Weaver Consultants Group

July 5, 2024
Project No. 0086-364-11-19

Re: Response to Comments
Tier III Permit Modification
Muskogee Community Recycling and Disposal Facility – Permit No. 3551020
Muskogee County, Oklahoma

FIGURE E-1-13A

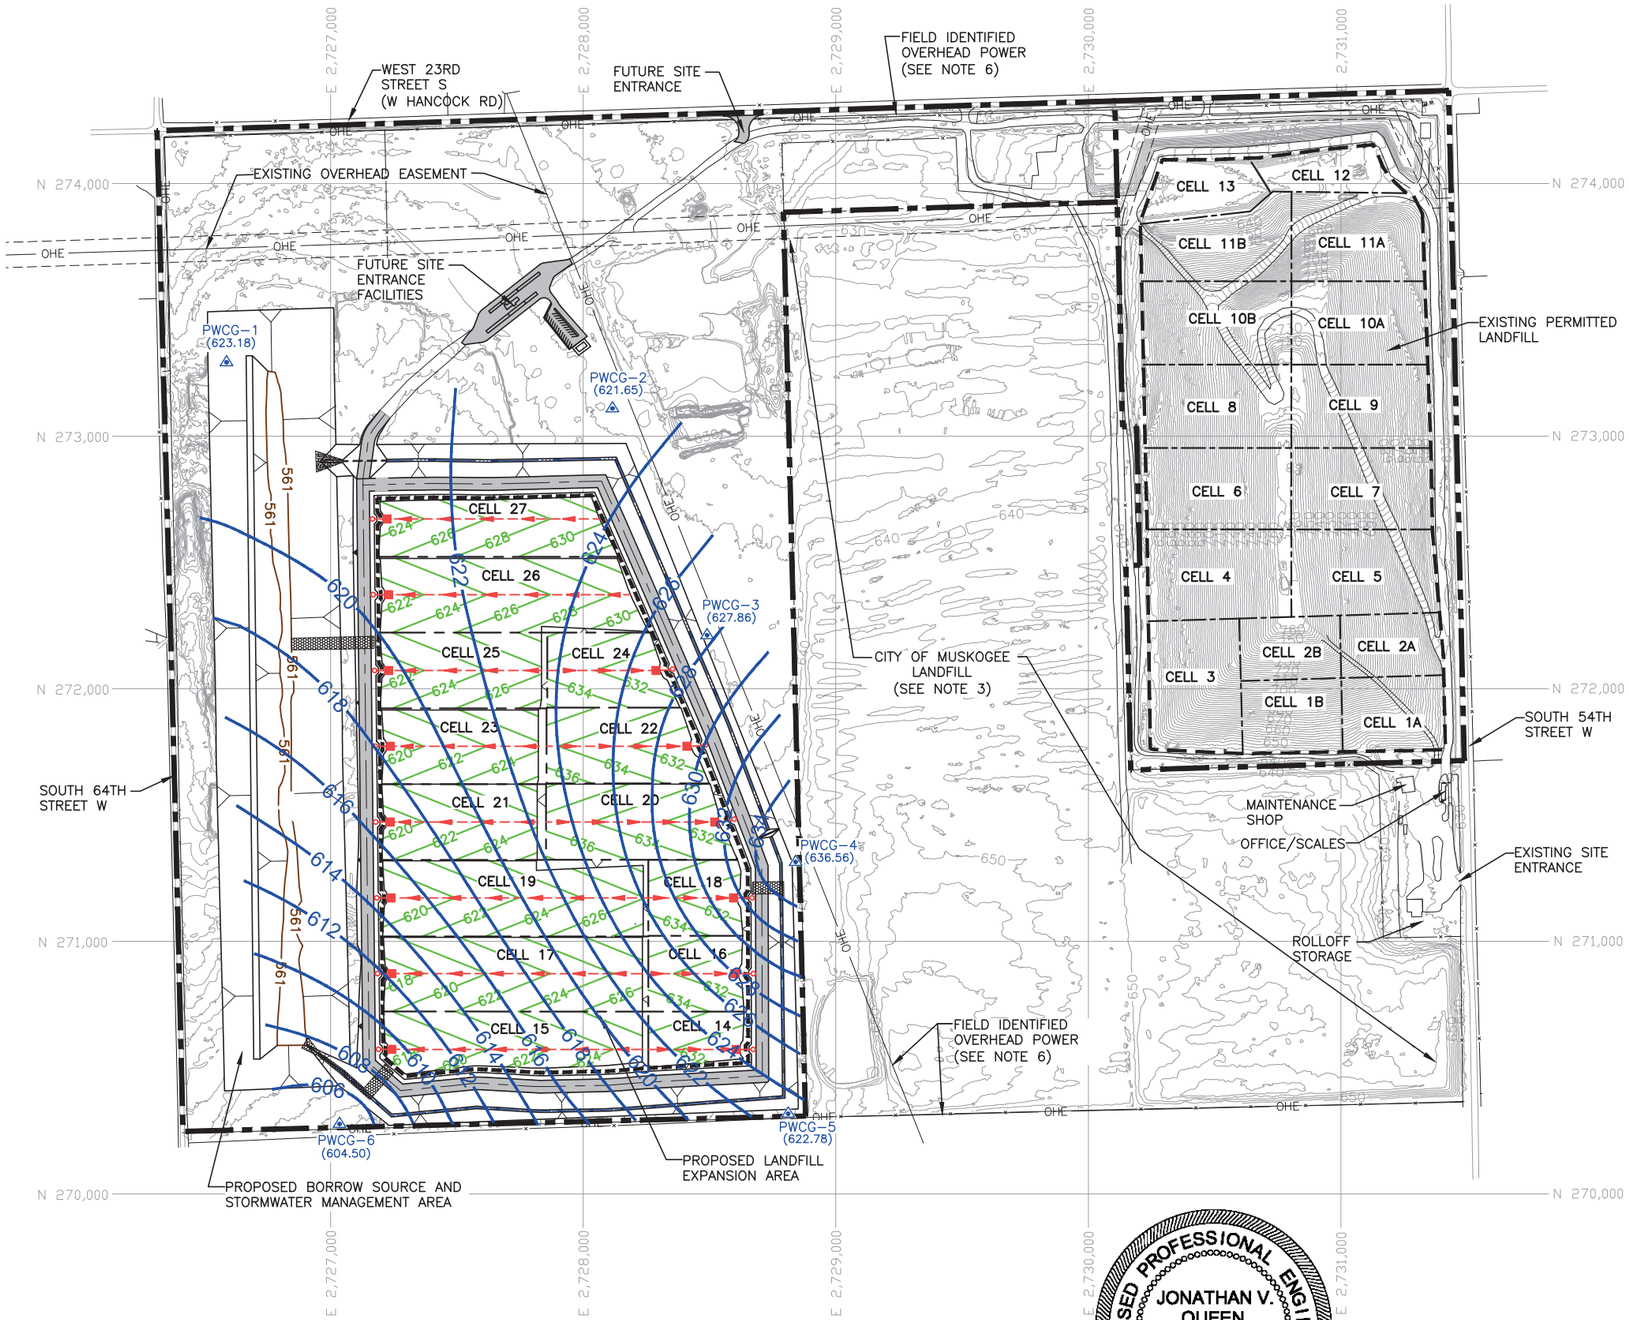
i. The Highest Measured Groundwater Potentiometric Head Surface Contour Map (Attachment E-1-12), and October 2022, December 2022, April 2023, July 2023 Potentiometric Head Surface Contour Maps (Figures E-1-13A, Figure E-1-13B, Attachment E-1-13C, and Attachment E-1-13D, respectively) in Appendix E, Volume 2A of the Application depict potentiometric head surface contours at five-foot intervals. In accordance with OAC 252:515-3-75(b)(1), please revise these figures and attachments to depict groundwater elevation contours at two-foot intervals.

Figures E-1-12 through E-1-13D in Appendix E of Volume 2A have been revised to depict groundwater elevation contours at two-foot intervals.

FIGURE E-1-15

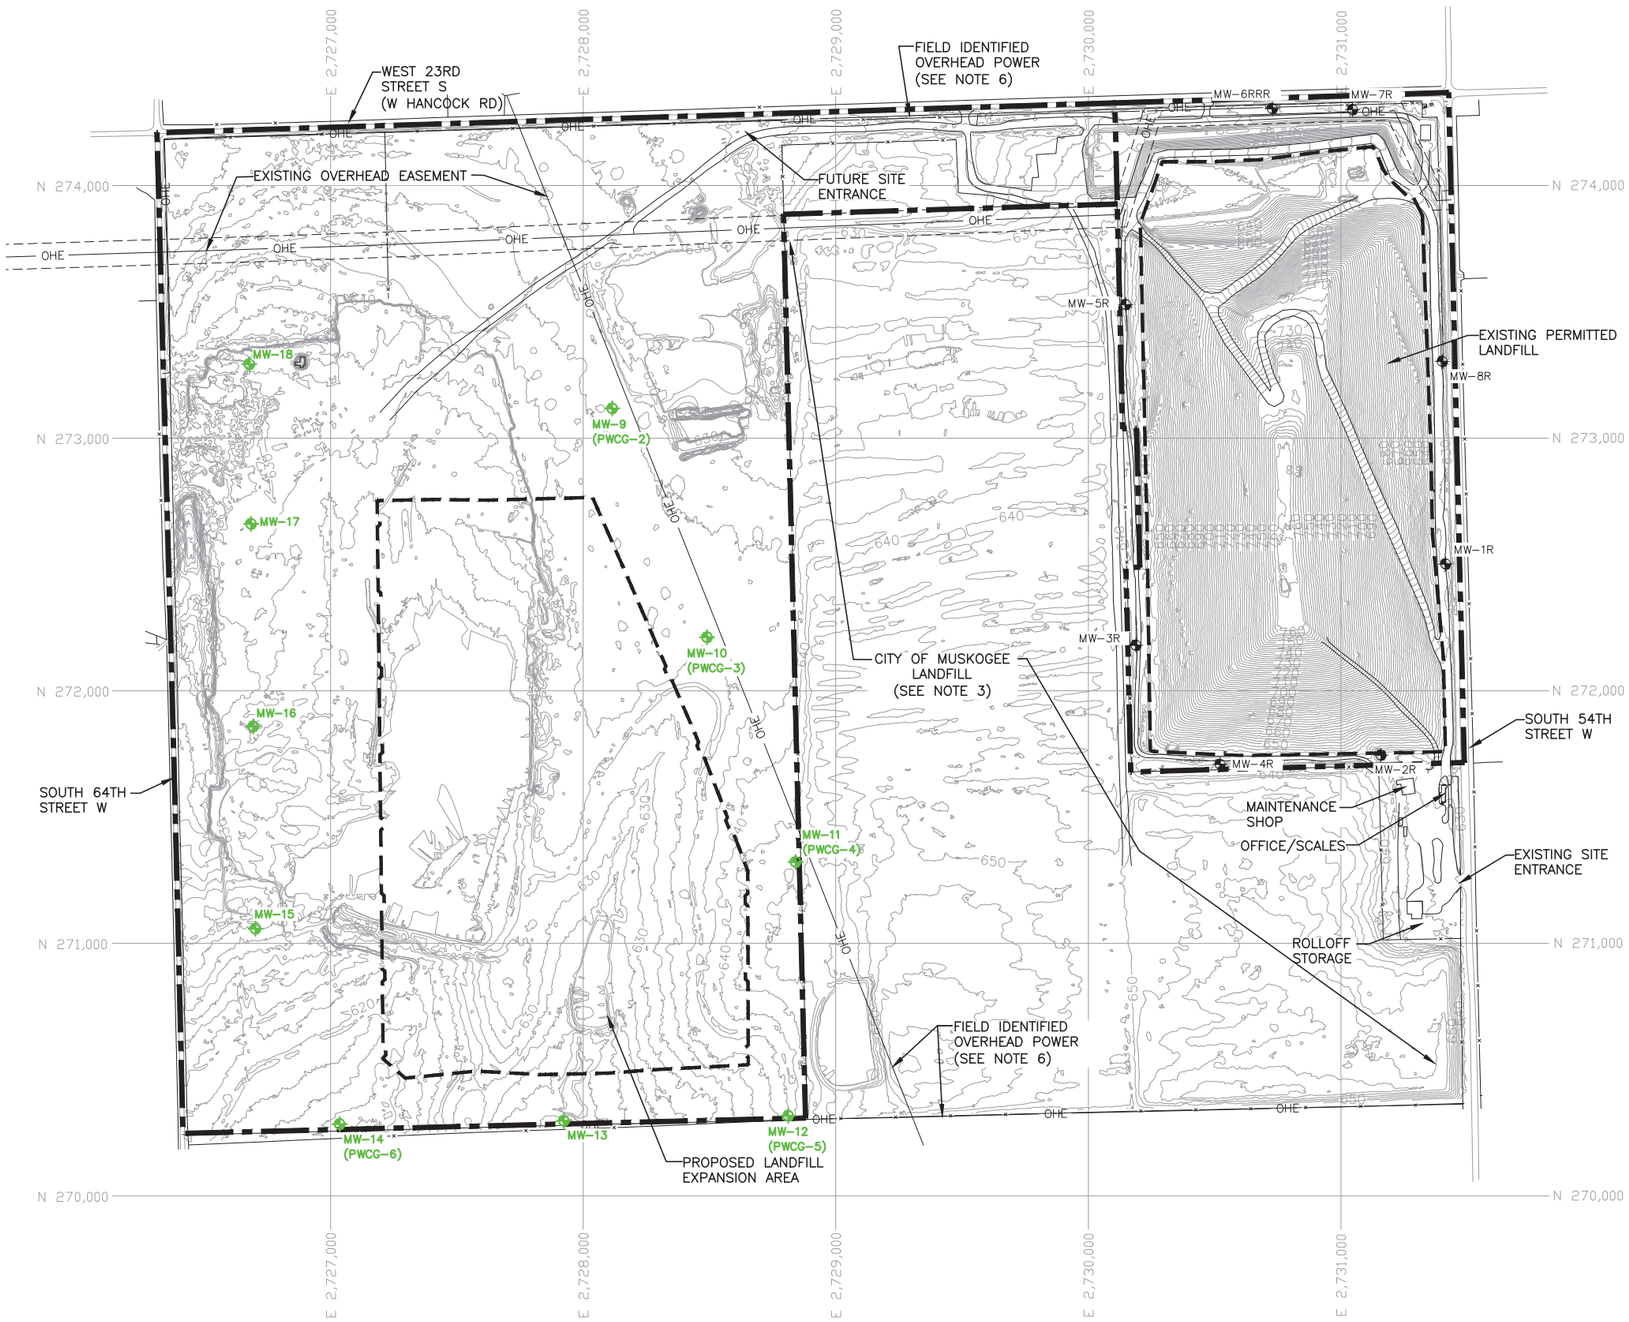
6. Groundwater Monitoring – The Proposed Groundwater Monitoring System (Figure E-1-15) in Appendix E, Volume 2A of the Application depicts the proposed groundwater monitoring wells with respect to the proposed expansion area. According to the scale provided in the figure, the wells on the western side of the proposed permit boundary are over six hundred (600) feet from the proposed limits of waste. In accordance with OAC 252:515-9-4(a) please relocate the proposed groundwater monitoring wells to be no more than 150 yards (-500 feet) from the boundaries of waste disposal.

Figure E-1-15 – Proposed Groundwater Monitoring System has been revised to move the western wells 500 feet from the waste disposal boundary. All drawings depicting monitoring well locations have been revised and included as part of this response.
